AMENDMENT OF SOLICITATION

1. This contract shall cover structural repairs to DLA Buildings 404 and 505 only. All references and plans for Buildings 205, 206 and 406 shall be disregarded as they are NOT part of this contract. Plan sheets 2 of 26 through 9 of 26 shall be disregarded. Exception: Plan Sheet 7 of 26 'GIRDER ELEVATION' shall be used in conjunction with Detail C on plan sheet 25 of 26.
2. Submission of Invoices: NFAS clause 5252.232-9301 is no longer valid; the correct clause is DFARS 252.232-7006. This section shall be omitted and the Contract Specialist shall provide instructions for submitting invoices.
3. Replace Work Order Number 1158199 with Work Order Number 1172316. Work Order Number 1158199 is no longer valid and all references shall be replaced with Work Order Number 1172316.
4. Replace Building No. 404 Table on S-602 with table listed below:

DETAIL E
NO SCALE

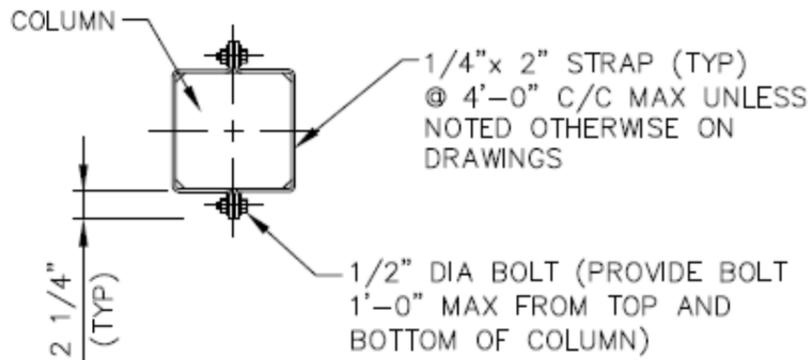
| BUILDING NO. 404 | | | |
|-------------------------|---------------|---------------|---|
| H11 | SPLIT | N/A | CONFLICT #3 H11: HAS CRACKS ON (2) SIDES, THEREFORE USE CLAMP PER "DETAIL E" IN AMENDMENT OF SOLICITATION #6 (Below) |

6. Alternate Column Repair Detail
